# SKYLINE AT LORSON RANCH

EL PASO COUNTY, CO  
**PLANNED UNIT DEVELOPMENT AND  
 PRELIMINARY PLAN**

# PUDSP V\_1 Planning Redlines Only.pdf Markup Summary 3-10-2021

**LS02**  
 SHEET 06 OF 07

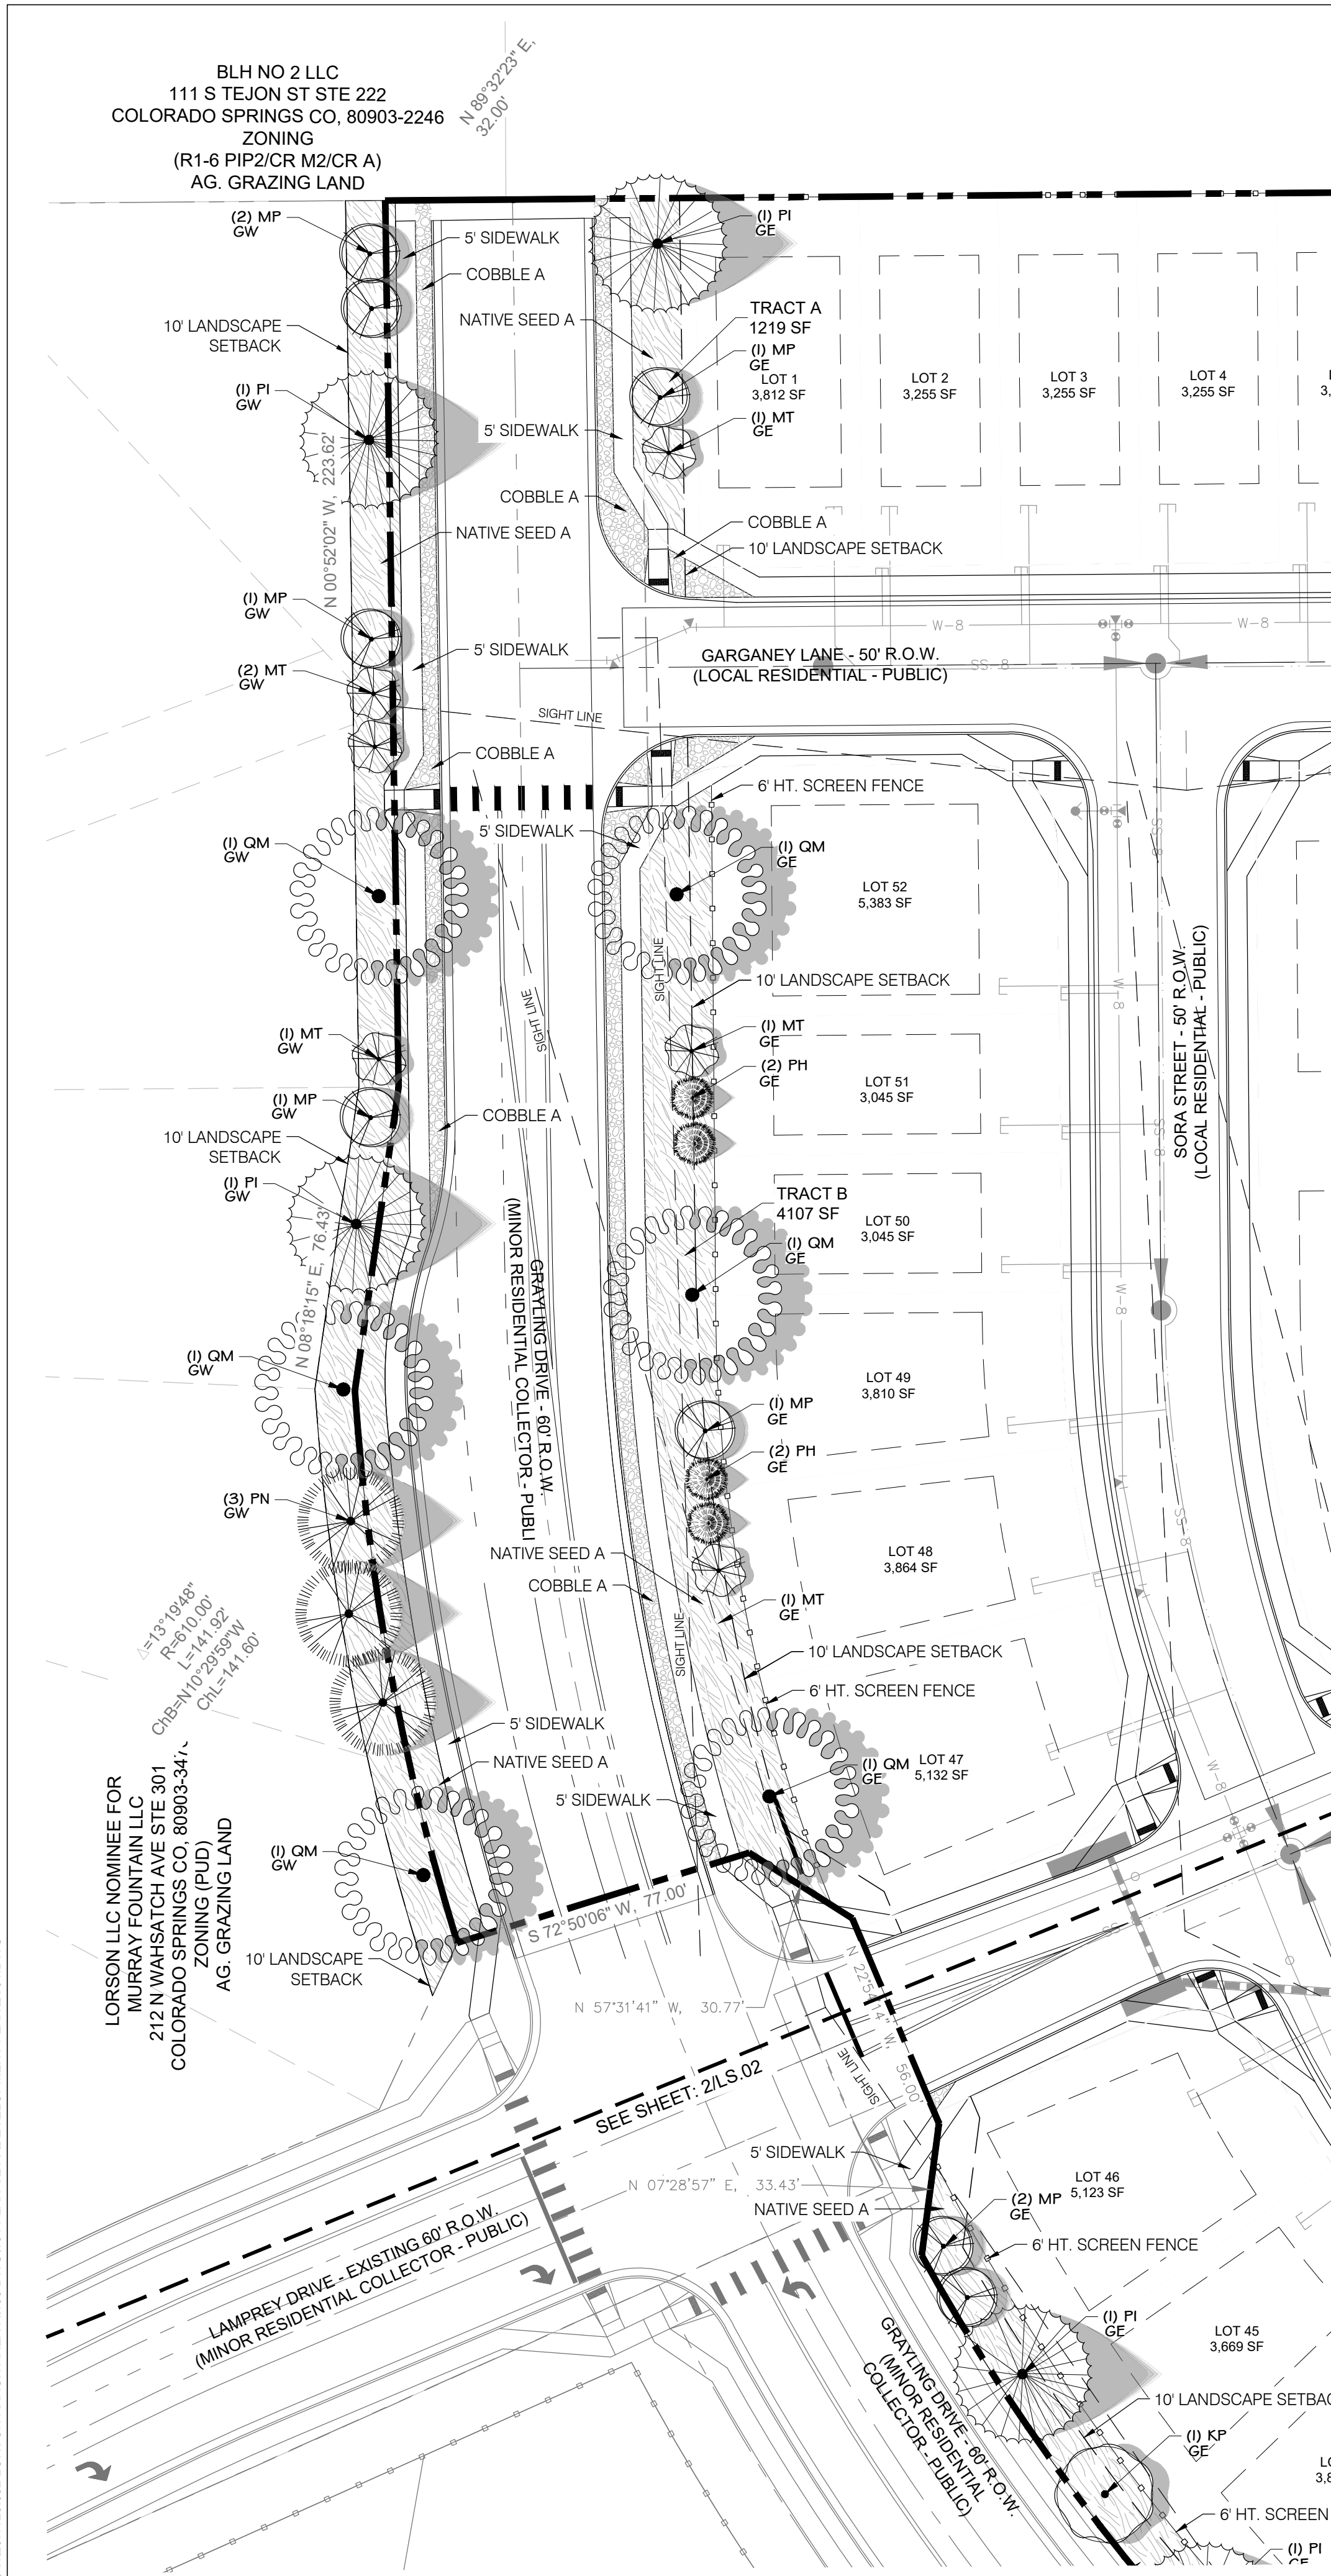
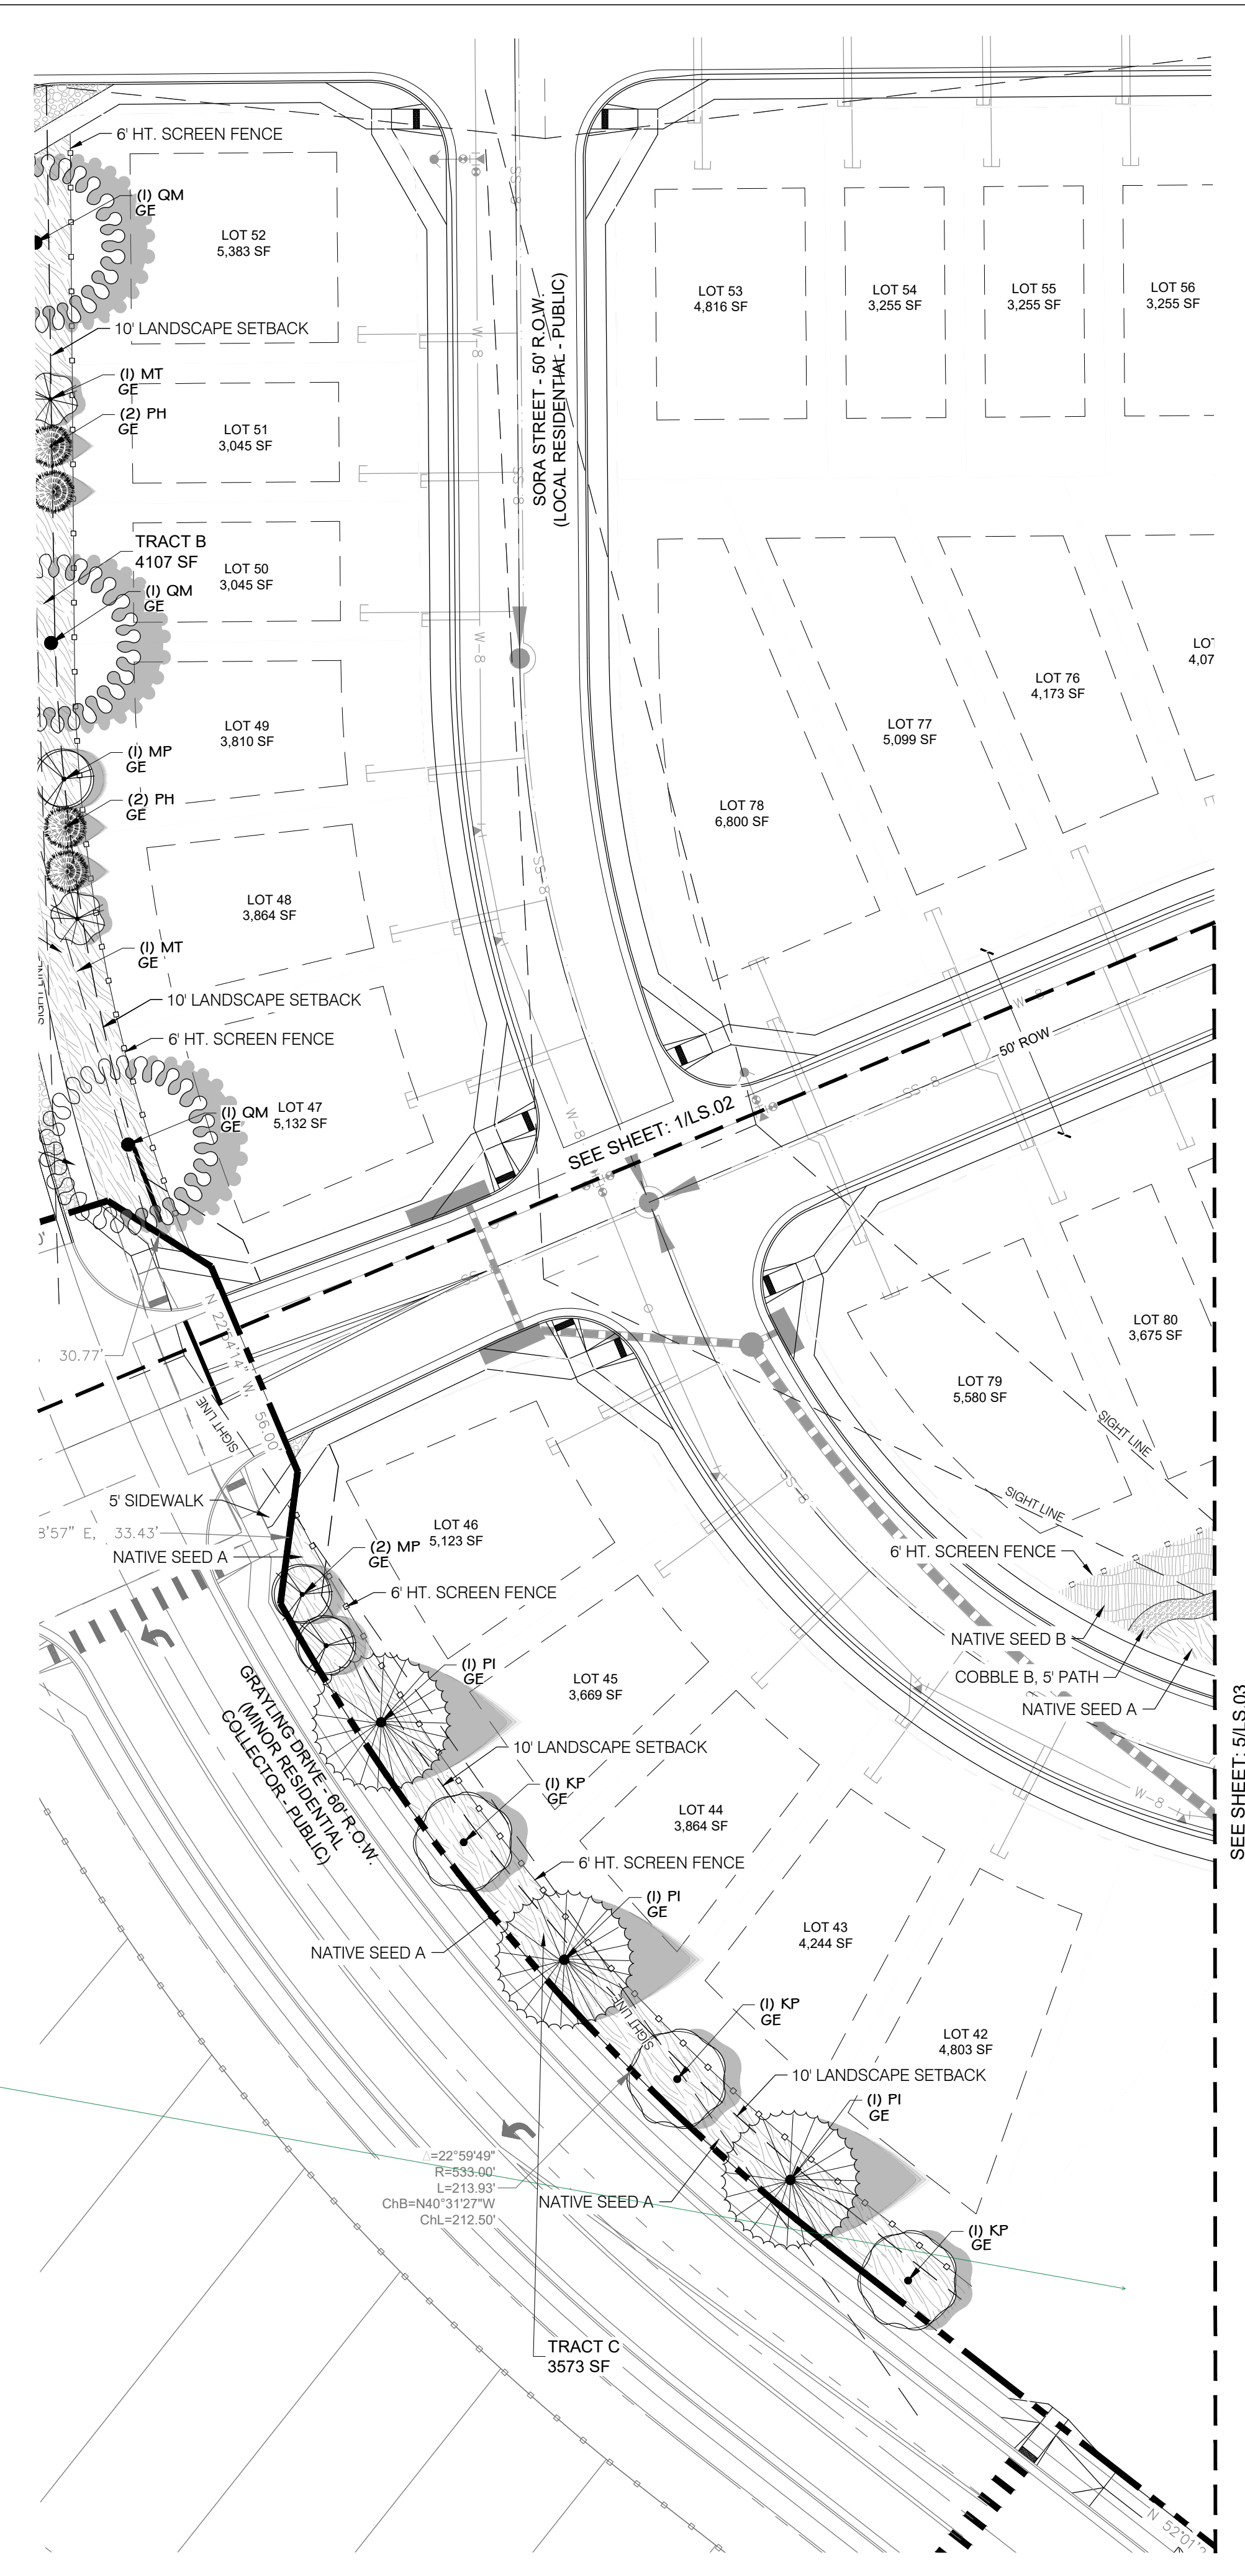
show details for pump station and landscape
